Technical Memorandum

Review and Reevaluation of Skagit River 1921 Flood Peak Discharge

Figure 2. Comparison of Stewart and USACE surveyed low-flow water surface elevations (NGVD-29)

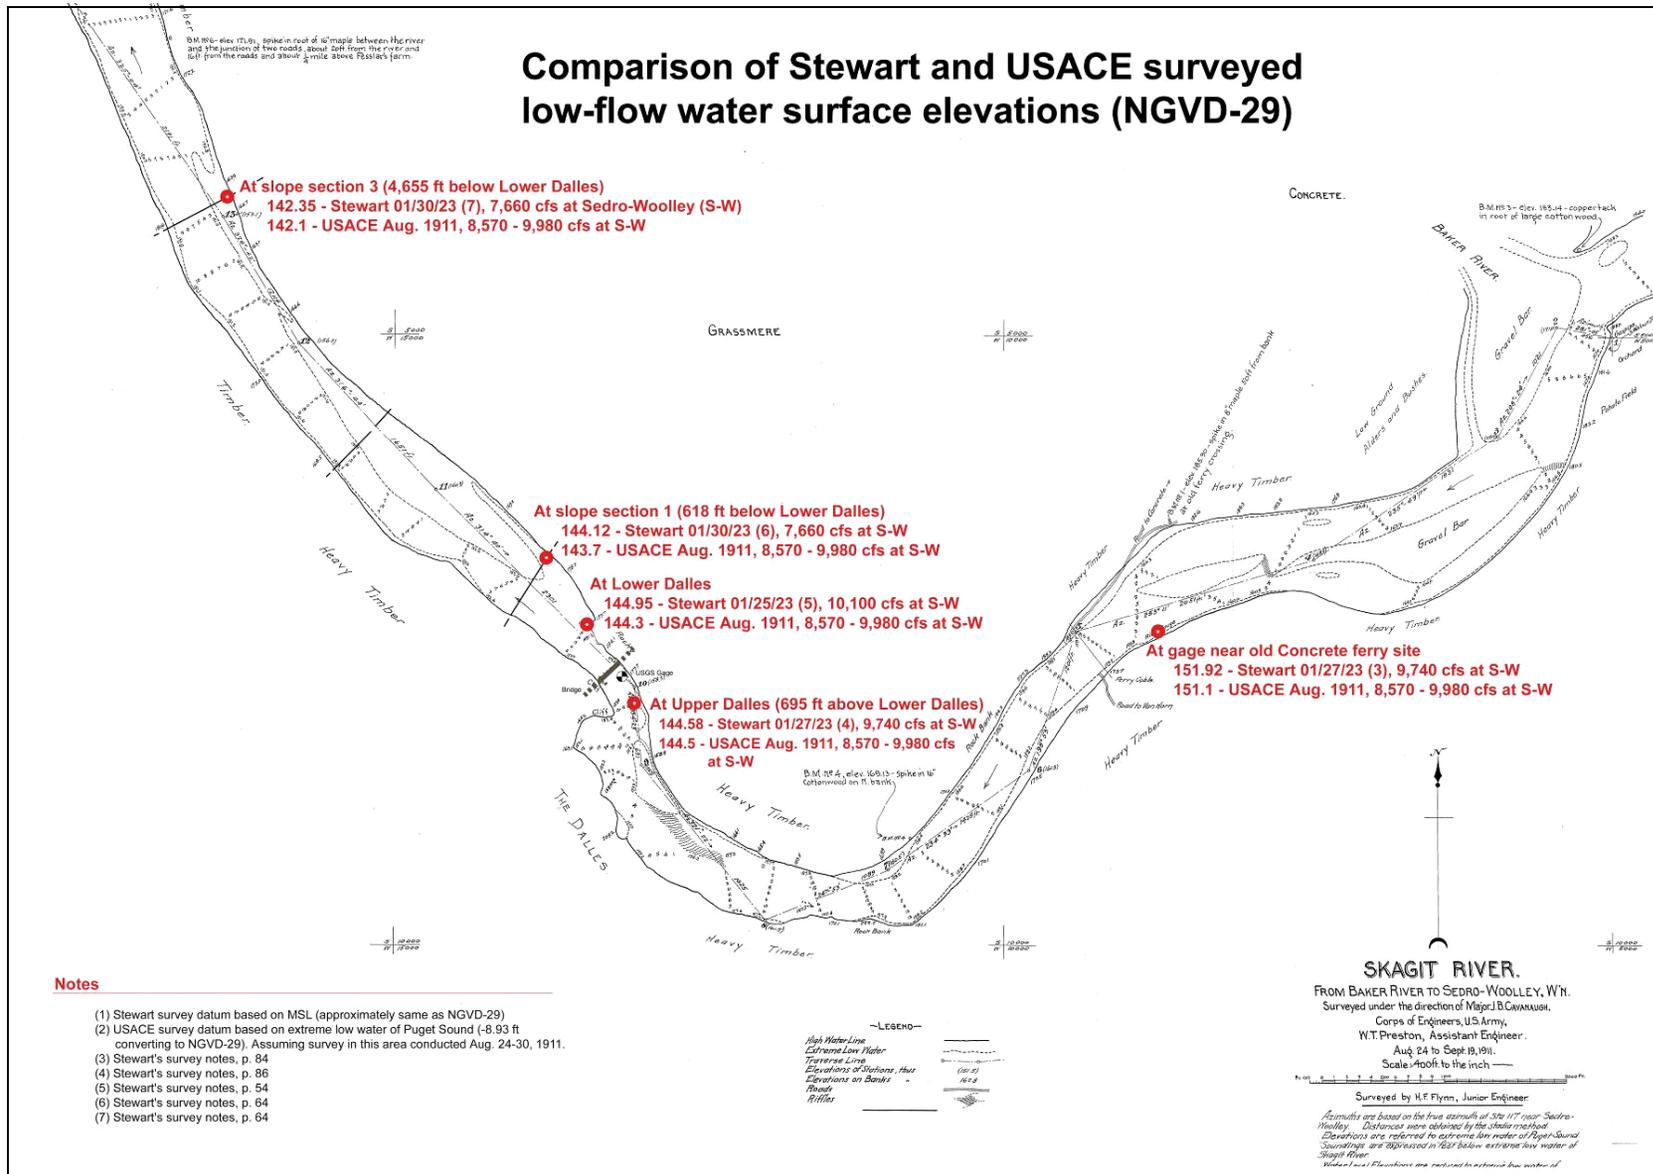
As shown in Table 2, Stewart's surveyed low-flow water elevations (based on his gage datum of 140.89) are between 0.18 feet lower and 0.82 feet higher than those surveyed by other parties.² Stewart's data are mostly higher, not lower. None of Stewart's surveyed elevations are near the 1.8-ft difference they should have been, if the USGS-asserted datum were correct. And as shown in Table 2, if using the USGS-asserted 1.8-ft higher gage datum of 142.69, Stewart's surveyed low-flow water surface elevations are between 1.62 and 2.62 feet higher than those surveyed by other parties, which is not reasonable.

Figure 3. Slope Section XS3 – Skagit River near Concrete, WA

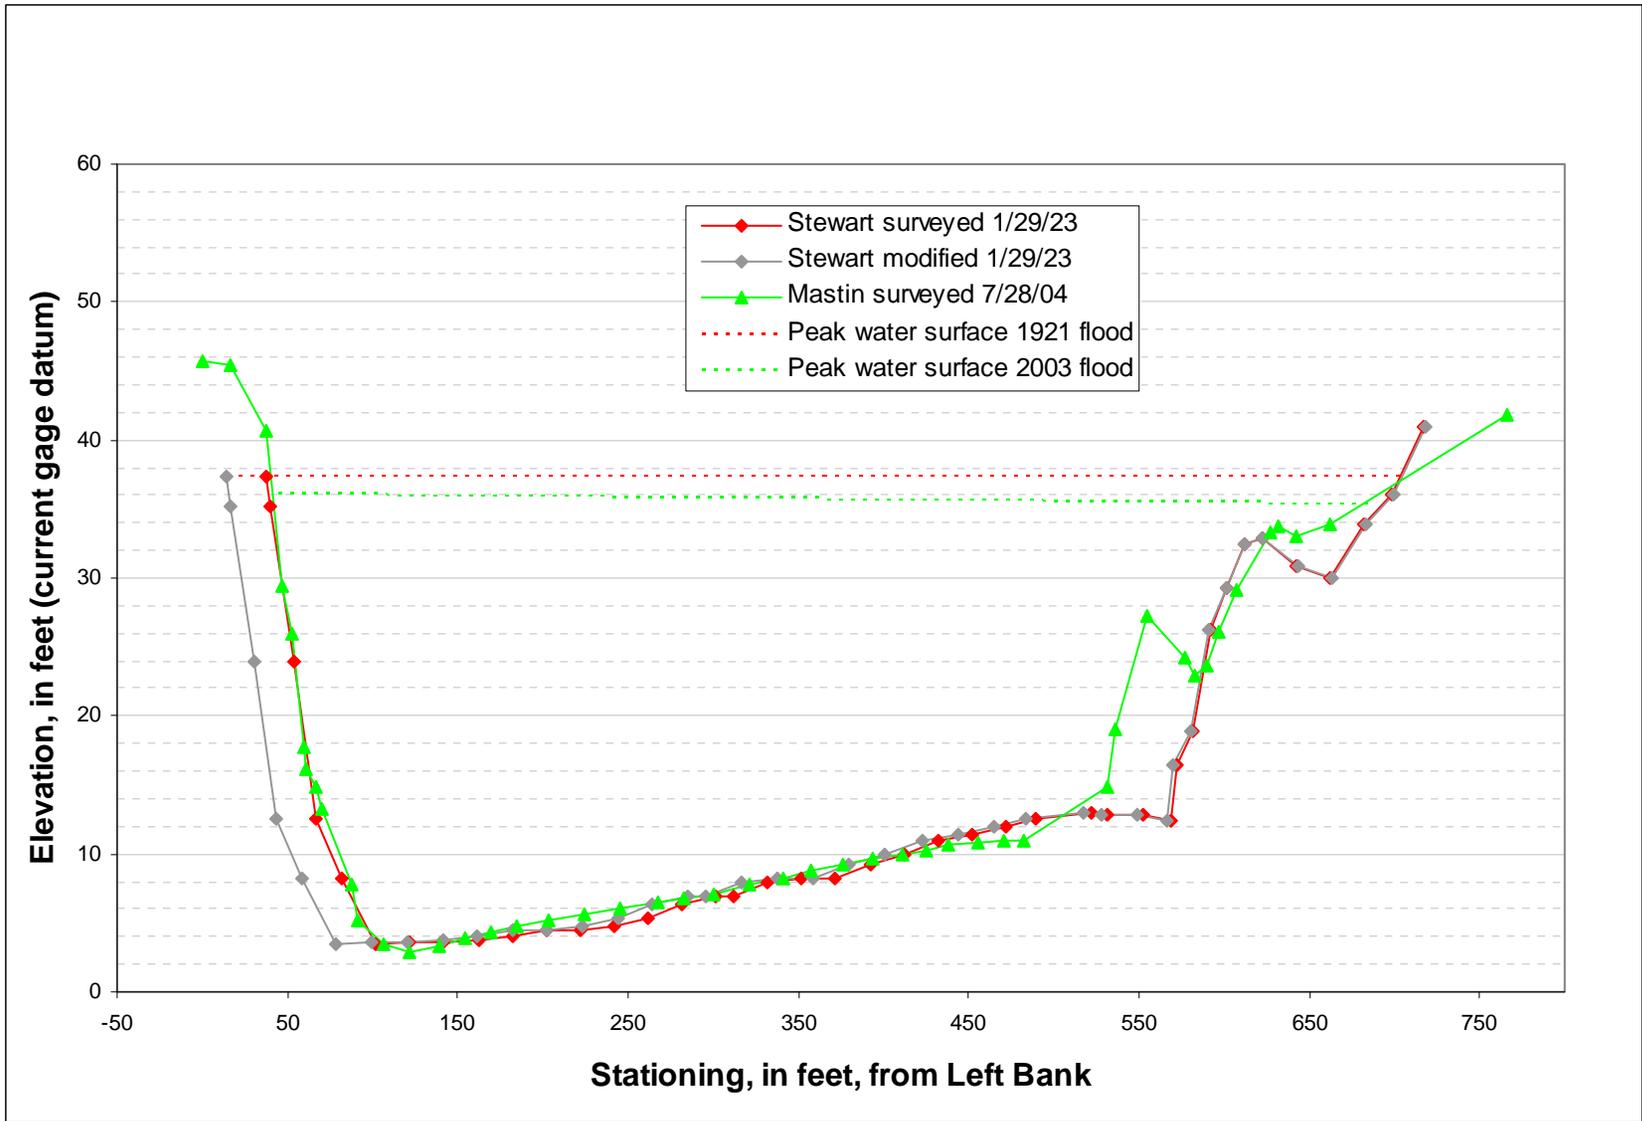
Stewart surveyed the lower slope section (XS3) on January 29, 1923 (see Stewart's survey notes, p. 78) (Stewart 1922–23). On January 31, 1923, while

surveying the upper slope section (XS1), Stewart checked the graduations on rope he used for the survey and noted this: *"Checked graduations on rope as follows. Markers 80 to 160, 84 1/2 on steel tape = 80 on rope 0 - 320 portion of rope. Taped dry and before stretching, 41.2 on steel tape = 40 on rope. This will apply from graduation 320 on. Checks on rope graduation were made while rope was still stretched across river. It is not certain that these checks are applicable to the lower cross section also but probably will have to be assumed so"* (see Stewart survey notes, p. 69). This meant that Stewart assumed his survey rope was also stretched by approximately 5% when he was surveying the lower slope section (XS3) and went ahead to modify his originally surveyed lower slope section without an actual verification of his assumption. (For Stewart's originally surveyed and modified data, see Stewart's survey notes, p. 78.)

Figure 3 shows plots of Stewart's originally surveyed and later-modified lower slope section. In 2004, Mastin and his field crew surveyed this section. The 2004-surveyed lower slope section is also shown in the figure for a comparison. This comparison indicates that Stewart's originally surveyed section appears accurate, matching the channel width and bottom elevations with the 2004-surveyed section better than his modified section. This comparison assumes that the 1923 and 2004 surveys are approximately at the same location, and that the change in cross section from 1923 to 2004 at this location is not significant.

Figure 4. 1921 and 2003 flood high water marks surveyed by Stewart (in 1922–23) and USGS (in summer 2004)

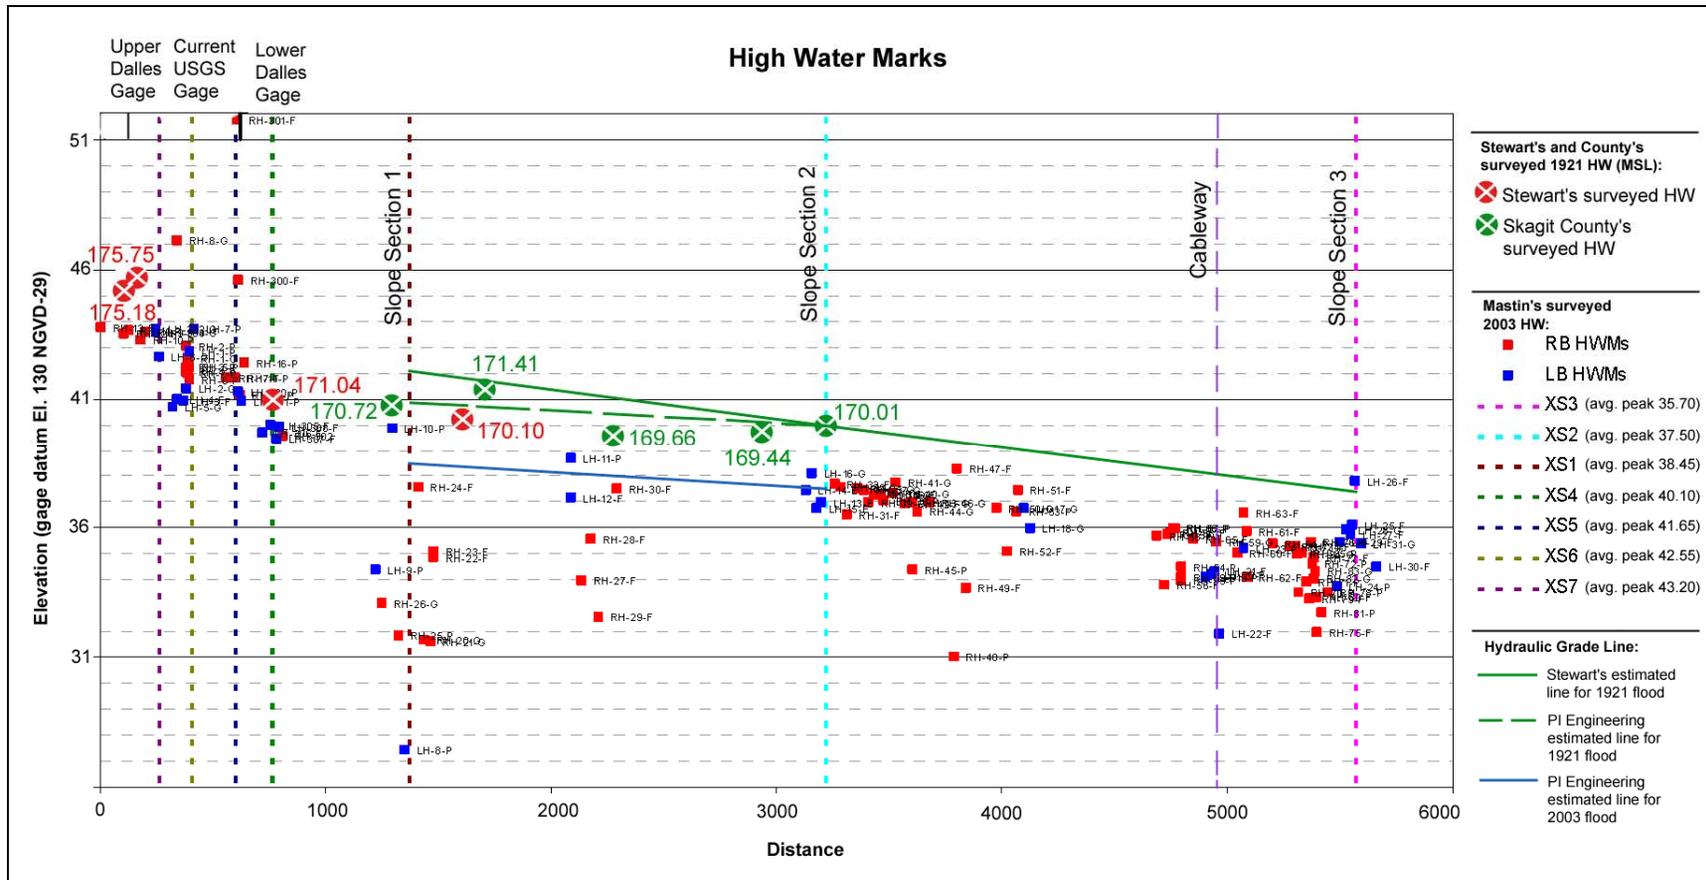
Stewart used 2.11 ft for the 1921 water surface fall between the upper and middle slope sections (XS1–XS2). This fall is not supported by the surveyed HWMs. The 1921 HWMs in the upper slope-area reach between XS1 and XS2 were surveyed by Skagit County staff on March 7–8, 1923, after Stewart left the area, and are documented on unpaginated loose note sheets as a part of Stewart's survey notes. Since Stewart's 1922–23 study was performed for Skagit County in accordance with an agreement between the County and the USGS (see Stewart's 1923 unpublished report, p. 1 (Stewart 1923)), these HWMs were probably field-marked by Stewart and then surveyed by the County under Stewart's direction. Table 5 lists the County's surveyed 1921 HWMs from the "Summary of H.W. Marks" on the last loose note sheet provided by USGS, as well as the HWMs surveyed under Stewart's direct control. The survey reference station (0+00) and elevation (lower Dalles gage datum El. 141.04, Stewart's survey notes, p. 67) are based on the location and gage datum of the lower Dalles gage set up by Stewart. The converted HWM elevations above NGVD-29 and above the current gage datum El. 130 are also listed in the table.

The slope sections XS1 and XS2 are located at 6+18 and 24+79, respectively (Stewart 1923, Exhibit B, p. 2). The corresponding 1921 HWMs at XS1 and XS2 are thus estimated to be approximately 40.86 (interpolating between County survey points 5+65 and 9+85, and ignoring Stewart’s survey point 8+65 for conservatism) and 40.01, respectively, above the current gage datum elevation of 130.00. The 1921 water surface fall between XS1 and XS2 is therefore 0.85 ft, not 2.11 ft used by Stewart. The corresponding slope of our estimated hydraulic grade line between XS1 and XS2 is therefore 0.000457 (= 0.85/1860), not 0.00113 used by Stewart (see Table 3).

As the flow is expanding from XS1 to XS2 and contracting from XS2 to XS3, the slope of hydraulic grade line should be flatter between XS1 and XS2 than between XS2 and XS3. Stewart’s calculation used a water surface fall value corresponding to a hydraulic grade line slope of 0.00113 between XS1 and XS2, which is not reasonable since this is very similar to the slope of 0.00120 between XS2 and XS3 (Table 3).

Figure 4 shows elevation plots of Stewart-surveyed 1921 HWMs and USGS-surveyed 2003 HWMs (surveyed in summer 2004 and provided in the spreadsheet Concrete_03_SAM.xls) in the Dalles and slope-area reaches. As shown in the figure, the 2003 flood HWMs also support the flatter hydraulic grade line slope between XS1 and XS2. Using the USGS-estimated average peak elevations 38.45 and 37.50 provided in the spreadsheet and listed in Figure 4, we estimate the hydraulic grade line slope between XS1 and XS2 for the 2003 flood to be 0.000511 ($= (38.45 - 37.50) / 1860$), which is very similar to our above-estimated slope of 0.000457 for the 1921 flood. The hydraulic grade lines used by Stewart for the upper and lower slope-section reaches (XS1–XS2 and XS2–XS3) are plotted on Figure 4, as well as those estimated by PI Engineering for the upper slope-section reach (XS1–XS2). Our comparison assumes no revision to Stewart-used lower reach hydraulic grade line. Figure 5 shows the location and elevations of Stewart’s surveyed 1921 HWMs in the Dalles and Concrete area.

Figure 6. Estimated 1921 flood peak vs. surge adjustment using slope-area method

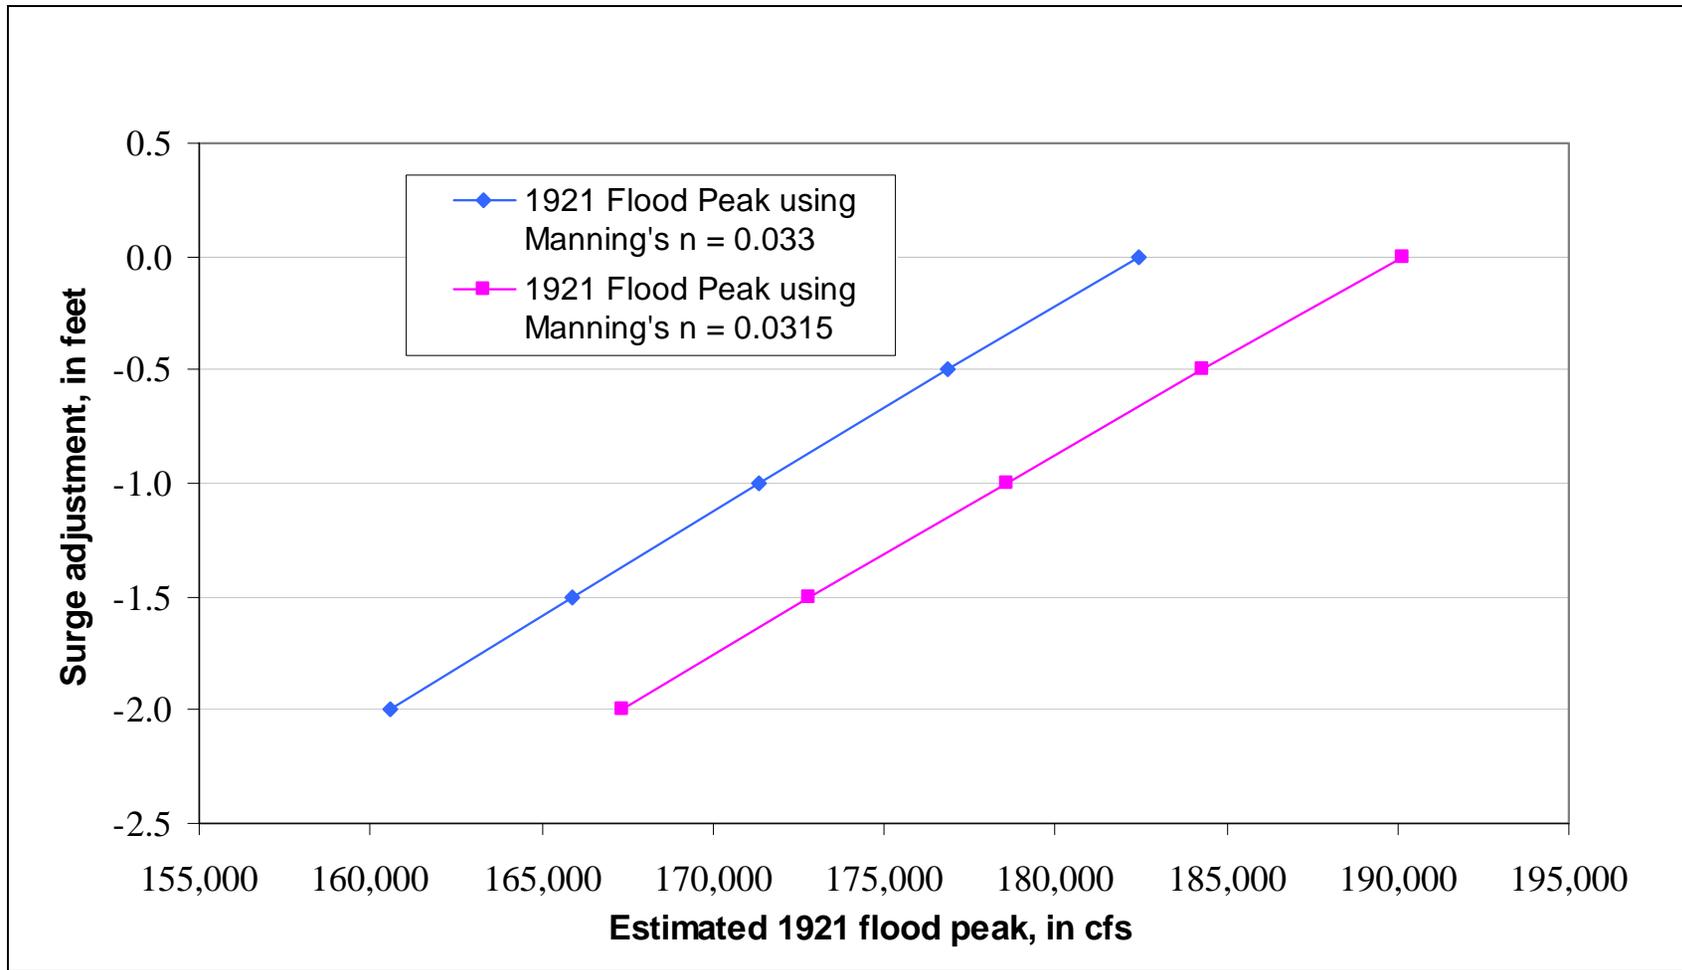
Table 7 presents a summary of the reevaluation results. Stewart's original estimates for all three slope-area reaches and the USGS-revised estimate for the lower slope-area reach are also shown in the table for comparison. Figure 6 shows the plots of the estimated 1921 flood peak versus surge adjustment with Manning's "n" values of 0.0315 and 0.033.

- All of the ten 1921 flood peak discharge estimates using Stewart's surveyed HWMs with five varying surge adjustments between 0.0 and 2.0 ft, and two varying Manning's "n" values between 0.0315 and 0.033, are substantially lower than both Stewart's original estimates in 1923 and the USGS-revised estimate in 2007.

- For each of the five varying surge adjustments, varying Manning's "n" values between 0.0315 and 0.033 would not result in a significant difference in the 1921 flood peak estimates. All of the differences due to these two "n" values are approximately 4%, which is within the expected accuracy of this reevaluation.

- The 1921 flood peak discharge would be between 172,000 and 205,000 cfs, averaging 190,167 cfs, if using Stewart's surveyed HWMs with a zero surge adjustment (which is too conservative) and using Manning's "n" value of 0.0315.

- The 1921 flood peak discharge would be between 143,300 and 174,800 cfs, averaging 160,567 cfs, if using Stewart's surveyed HWMs with a 2.0-ft surge adjustment (which is too aggressive) and using Manning's "n" value of 0.033.

- The average 1921 flood peak discharge would be 176,833 and 184,333 cfs if using Stewart's surveyed HWMs with a surge adjustment of 0.5 ft (which is conservative) and using Manning's "n" value of 0.033 and 0.0315, respectively.
